MEMORANDUM

Date: 9/1/2016
To: Planning Commission
From: Yesenia Jimenez, Associate Planner
Re: 1220 Bay Laurel Drive – Balcony screening condition

CHUKKAPALI RESIDENCE

1220 BAY LAUREL DRIVE MENLO PARK, CA 94025

SHEET TITLE:
 (N) Second Floor Plan w/ Lower Roof Plan

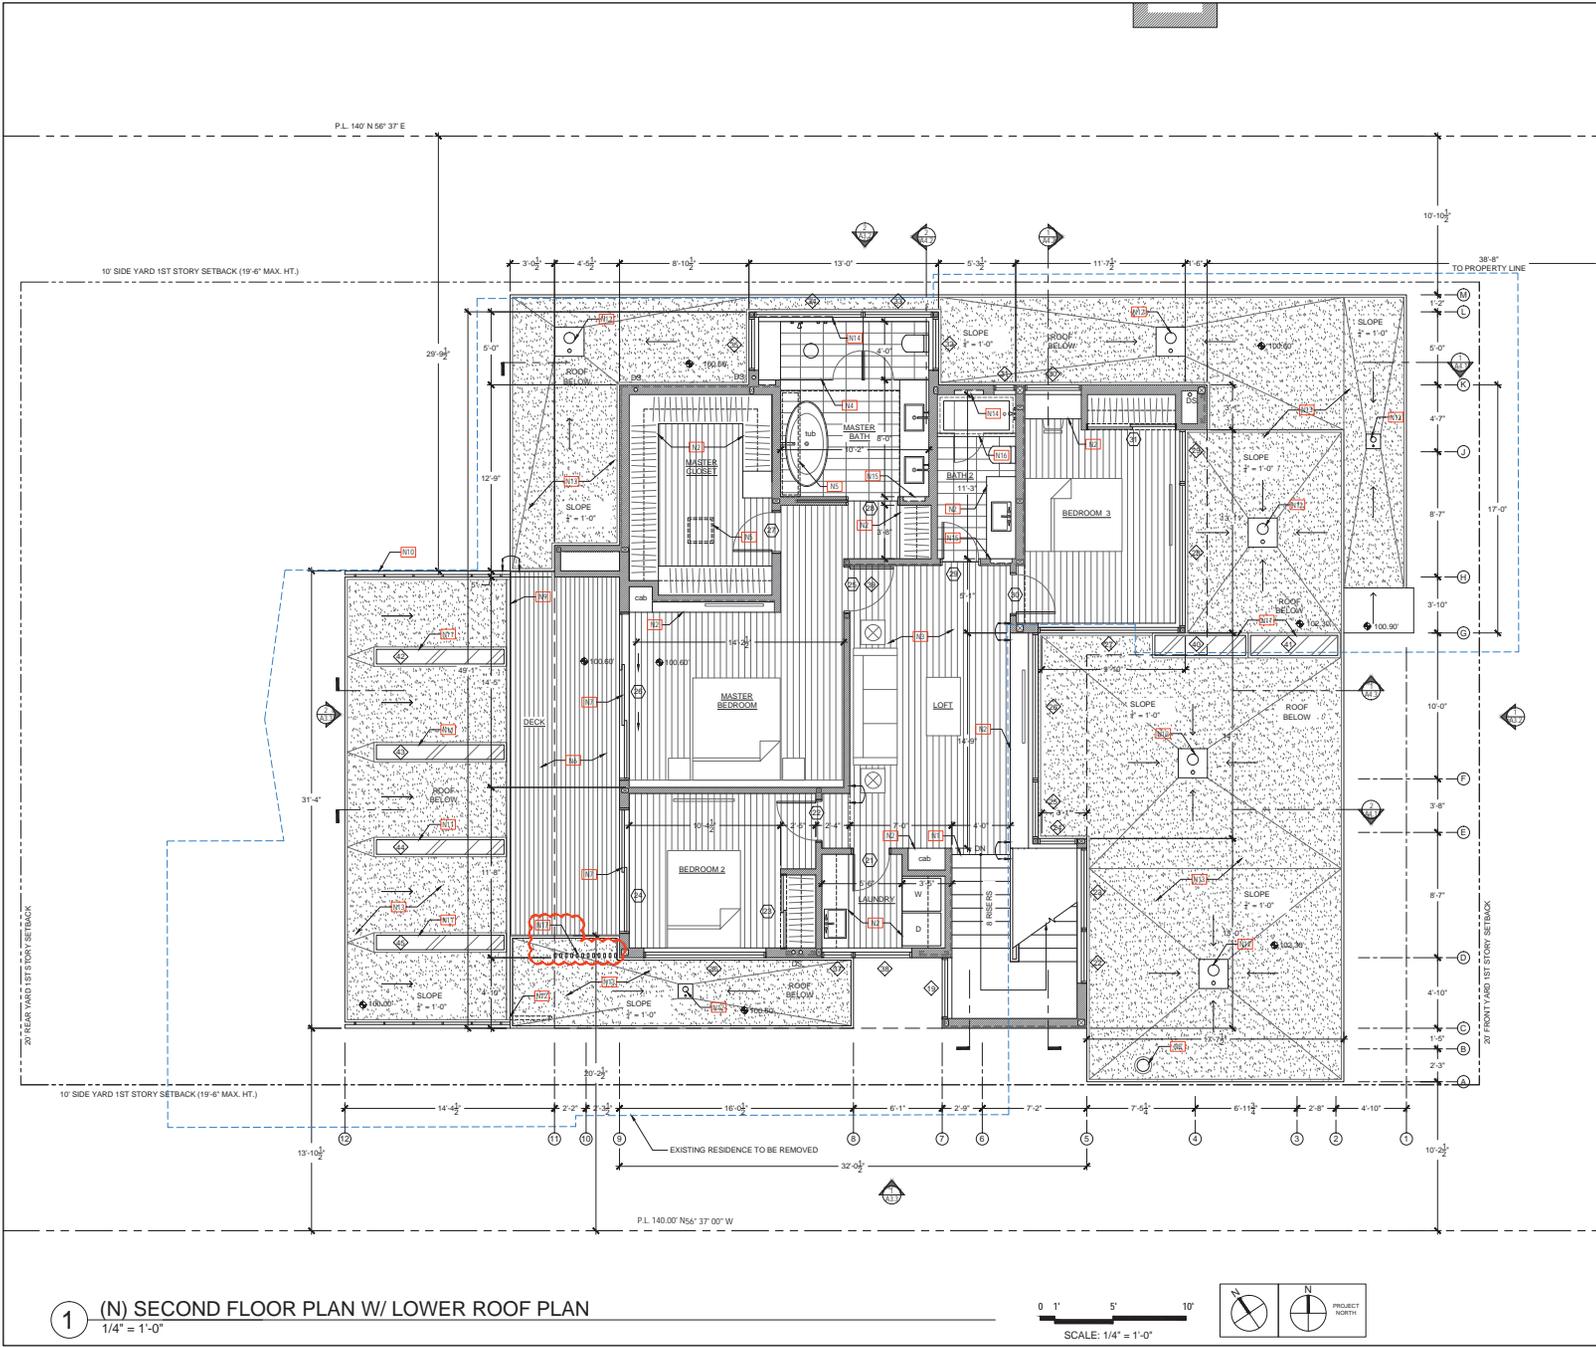
Since the May 9th meeting, the applicant has submitted revised plans, included as Attachment B. Staff has determined that the changes to the new balcony as shown

on the left and rear elevations (Sheet A3.3) and the second floor floor plan (Sheet A2.4) of the revised plan set address condition of approval 4a. The proposed wooden slat screen next to the left side of the second floor balcony would adequately screen the majority of views between the balcony and the adjacent property at 300 Santa Rita Avenue. The new slat screen would also be compatible with the design and materials of the overall residence.

- PROPOSED KEY NOTES:**
- N1 (N) STAIR AND HANDRAIL. SEE SHEET A7.3
 - N2 (N) CABINETRY AND/OR FIXTURE
 - N3 (N) WOOD FLOORING
 - N4 (N) CURBLESS SHOWER W/ GLASS ENCLOSURE. SLOPE FLOOR 2"=1'-0" TO LINEAR TRENCH DRAIN. FIT TO WIDTH OF SHOWER
 - N5 (N) SKYLIGHT (ABOVE)
 - N6 (N) WOOD DECK
 - N7 (N) SLIDING DOOR
 - N8 (N) PAINTED METAL CHIMNEY FLUE
 - N9 (N) GLASS HANDRAIL W/ STAINLESS STEEL TRIM CAP
 - N10 (N) PATIO CANOPY
 - N11 (N) SKYLIGHT (BELOW)
 - N12 (N) ROOF DRAIN
 - N13 (N) TPO ROOFING. 1ST FLOOR ROOF ADJACENT TO 2ND FLOOR BALCONY TO RECEIVE LANDSCAPE PEBBLES @ TPO
 - N14 (N) SHOWER NICHE
 - N15 (N) MIRRORRED RECESSED MEDICINE CABINET
 - N16 (N) BATH TUB W/ GLASS SHOWER ENCLOSURE
 - N17 2X4 WOOD SLAT SCREEN (PER PLANNING COMMENT 5/11/18)

A3.3

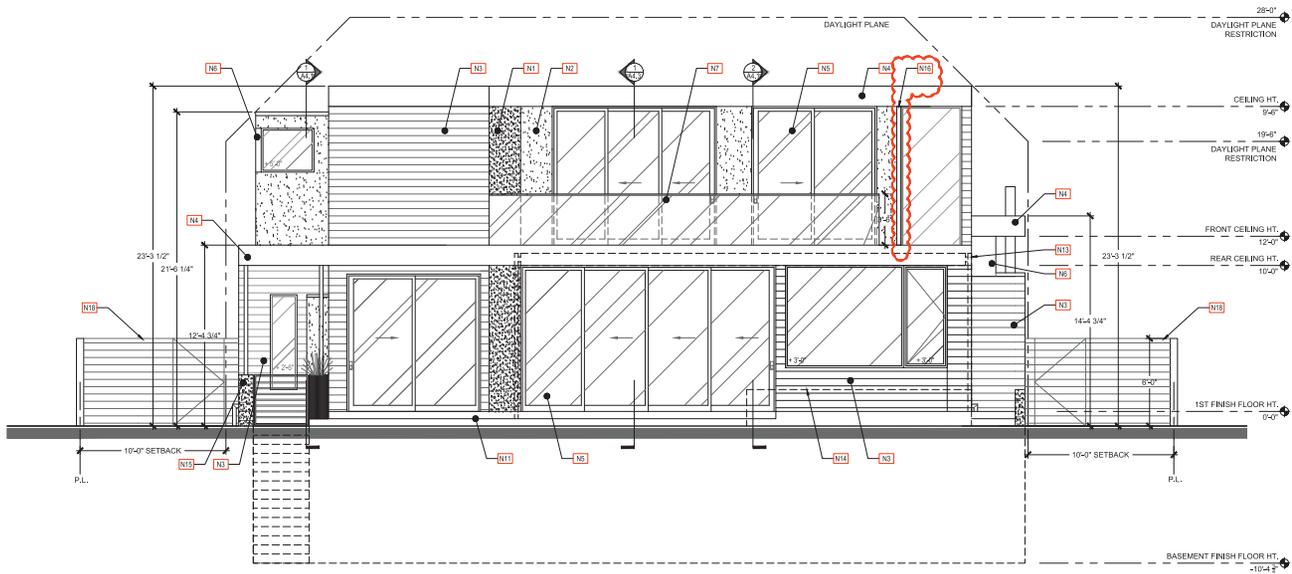
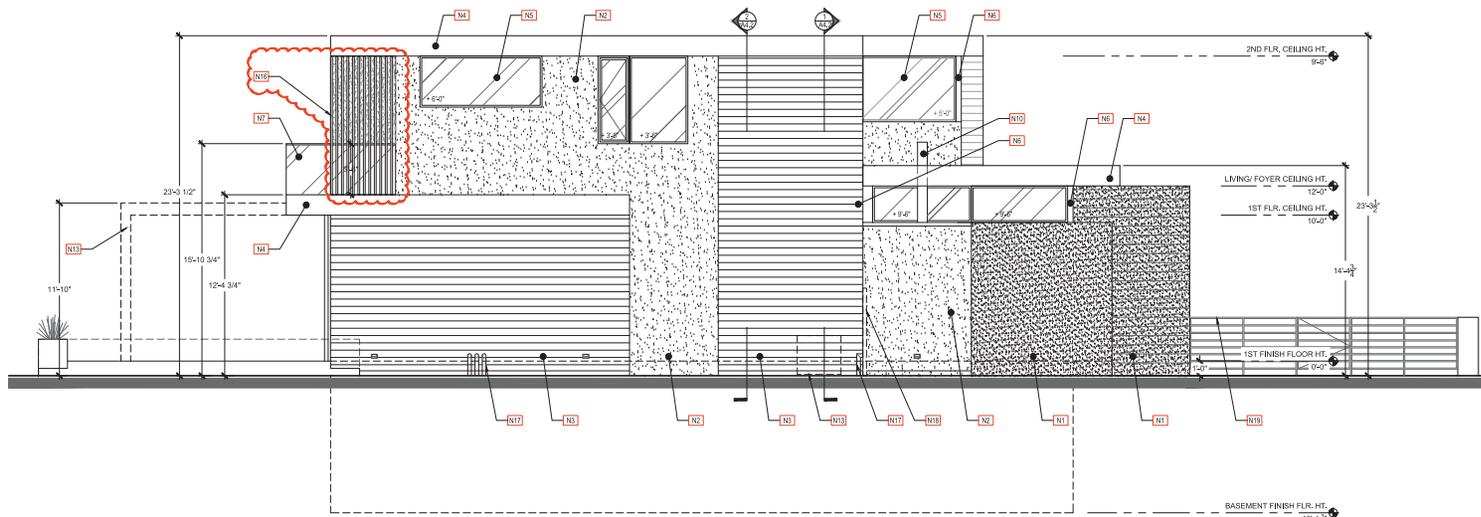
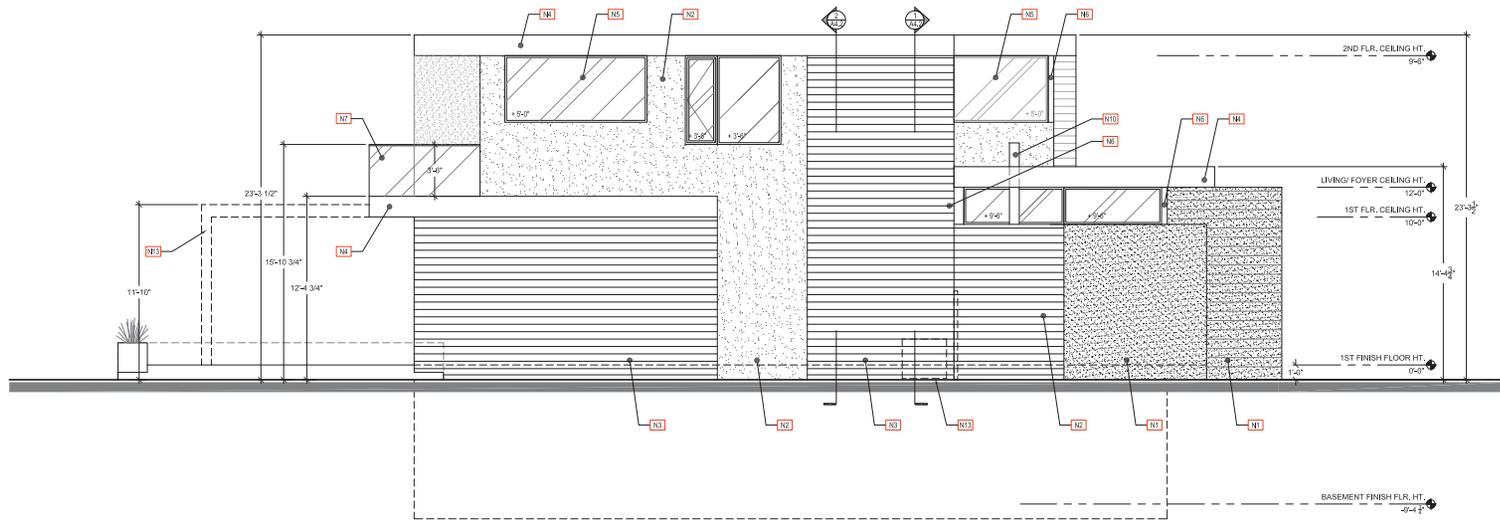
- a. *Simultaneous with the submittal of a complete building permit application, the applicant shall submit revised plans modifying the second floor balcony at the rear of the residence, which shall have the objective of providing screening views to the adjacent parcel at 300 Santa Rita Avenue on the left side of the subject property. The revised plans shall be subject to the review and approval of the Planning Division. The Planning Commission shall be notified by email of this action, and any Commissioner may request that the Planning Division's approval of the revised elevation may be considered at the next Planning Commission meeting. The revised elevation shall be fully approved prior to the issuance of the overall building permit.*
